45 Macquarie Street Parramatta MOD4 SHI Report
6 August 2014

Proposed Modification (MP09_0167 MOD4) Archaeological Display Precinct 45 Macquarie Street, Parramatta Statement of Heritage Impact

Sections illustrating how the new structure around In-site Archaeology will be arranged

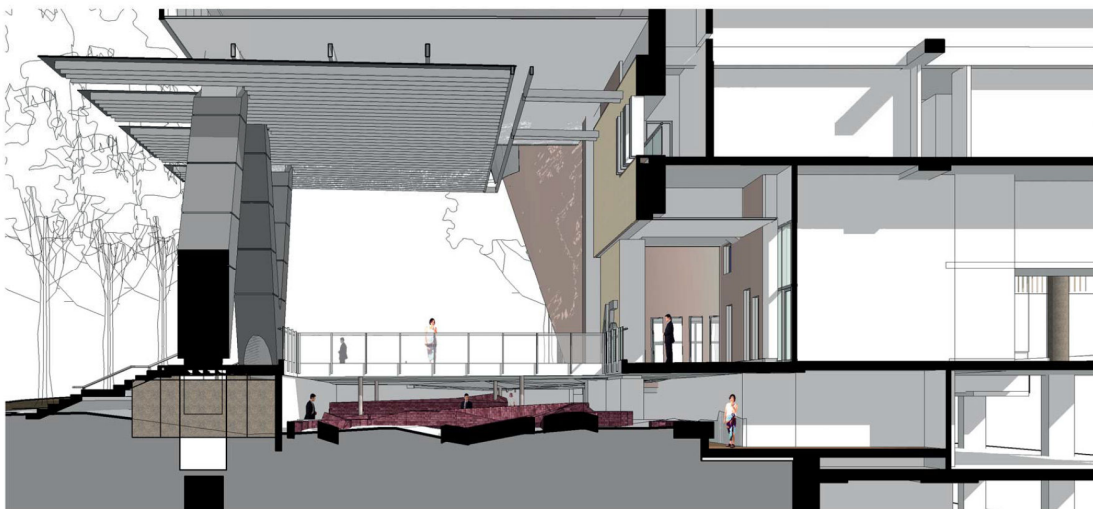
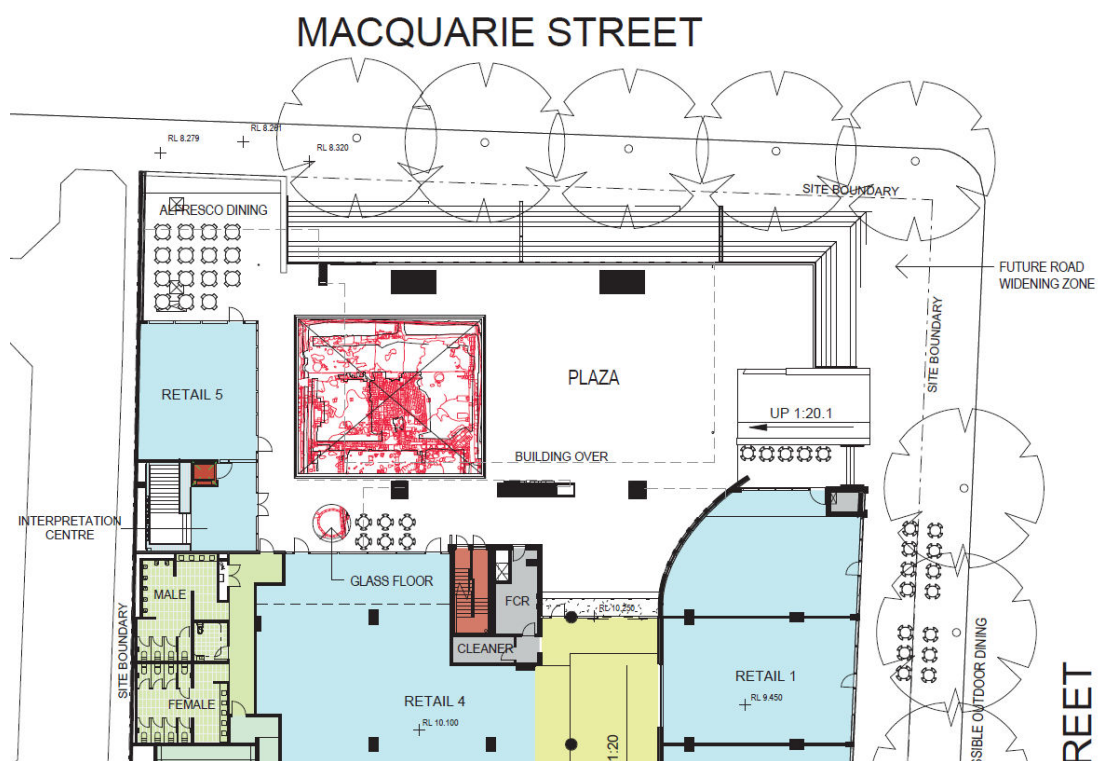
The revised layout of the Plaza and Basement Level Archaeological Display and Interpretation Centre has achieved the following positive outcomes:

- The modified layout for the Plaza Level has achieved a suitable and equitable balance between the need for a highly visible Entry to the Archaeological Interpretation Centre with the need to create a lively retail environment and opportunities for the Plaza to be utilised for entertaining community events.

- Entry to the Archaeological Interpretation Centre is now clearly visible on the axial pedestrian approach beside the Plaza opening.
- Glazed circular window over well will continue to provide viewing opportunities and natural lighting to archaeology while improving the circulation around the main archaeology viewing opening in the Plaza.

- Access to the new Plaza Level toilets is separated from the Interpretation Centre Entry.
- Archaeological Display Consultants have advised that the revised layout, sizing and identity are suitable as a backdrop for the design and installation of a high quality Interpretive Display at both Plaza and Basement Levels.

- The addition of a Maintenance Store at Basement Level has been in response to a direct request from the Consultant Archaeologist.
